STATE OF NORTH CAROLINA  
DEPARTMENT OF TRANSPORTATION

Subject: **Revised Permit Modification Request for the Section 404 Individual Permit, Section 401 Individual Water Quality Certification and CAMA Major Permit** for the proposed improvements to US 70 from existing four lanes at Radio Island to north of Olga Road (SR 1426), Carteret County, State Project No. 8.1162501, Federal Aid Project STPNHF-70(43), TIP R-3307. Debit \$570 (NCDWR) and \$100 (NCDCM) from WBS 34528.1.1.

References: Section 404 Permit No. SAW-2010-02125, issued September 27, 2013  
Section 401 Permit No. 3195, issued April 30, 2012  
CAMA Major Development Permit No. 37-12, issued May 3, 2012  
Permit Modification Request, dated September 23, 2014

Permit Drawing  
Sheet 5 of 34  
REVISED 9-23-14

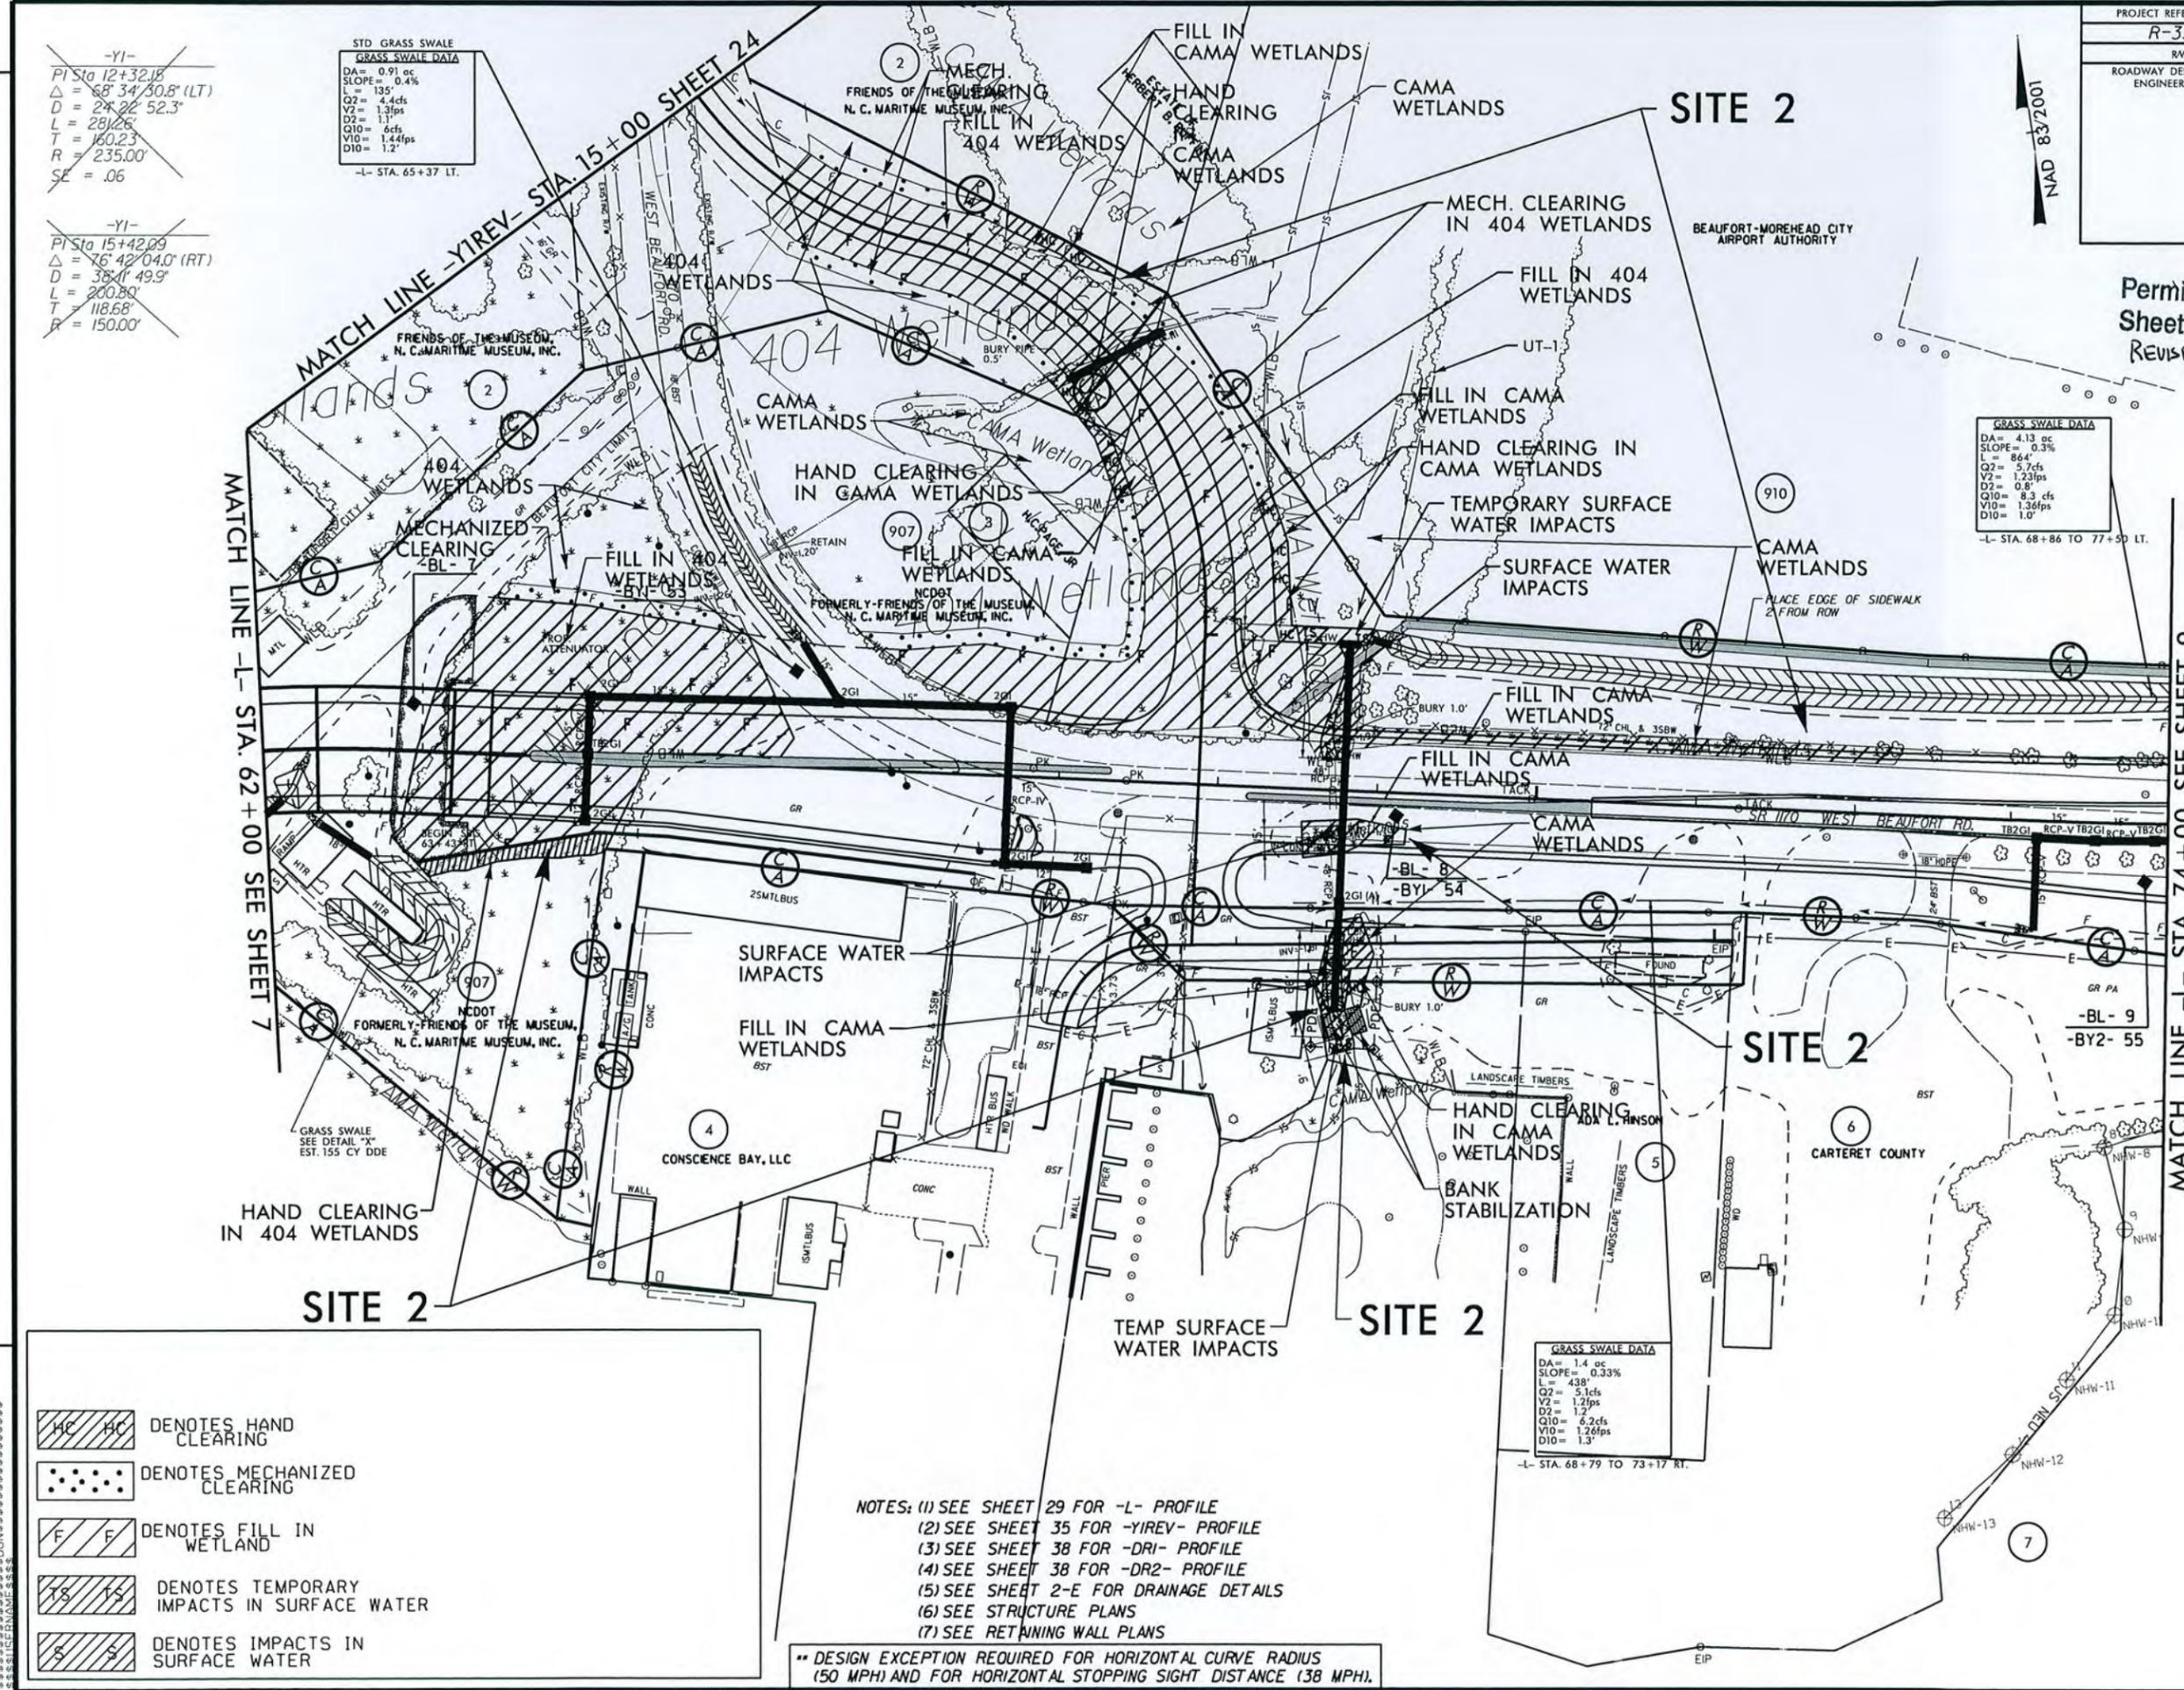
Please note, a revision has been made on permit drawing sheet 5 (plan sheet 8, -L- Sta. 63+43). The original permit drawings erroneously illustrated the fill within the retaining wall at the approach. This has been corrected, resulting in a 0.01 acre impact increase to 404 wetlands at site 2.
